UNITED STATES PATENT AND TRADEMARK OFFICE

10/668,255

Thomas J. Hunt

Continuation of box 11:

OGATA:

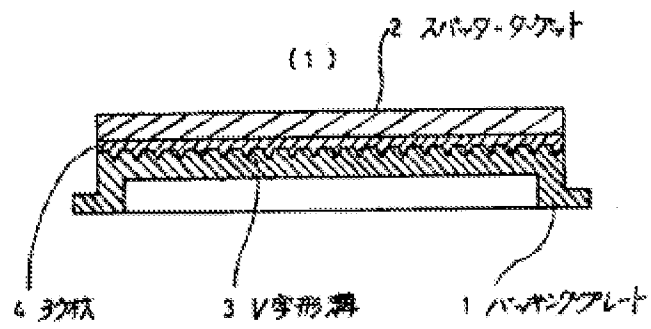
The examiner respectfully disagrees as the applicant has failed to provide a persuasive argument or evidence that the ridges of Ogata will not act as stand-offs during the bonding process. Thus, the examiner maintains the position that the ridges of Ogata inherently act as spacers/standoffs for the supply of soldering material between the backing plate and the sputter target. Please note the similarities between Figure 1 of Ogata and Figure 2 of the instant application. The structure of the ridges of Ogata is so similar to that of the instant application that one of ordinary skill in the art would expect the ridges of Ogata and the instant application to function in the same manner. Thus, even through Ogata explicitly teaches using ridges to control warpage, the ridges of Ogata will also aid in forming a uniform thickness solder bonded interface.
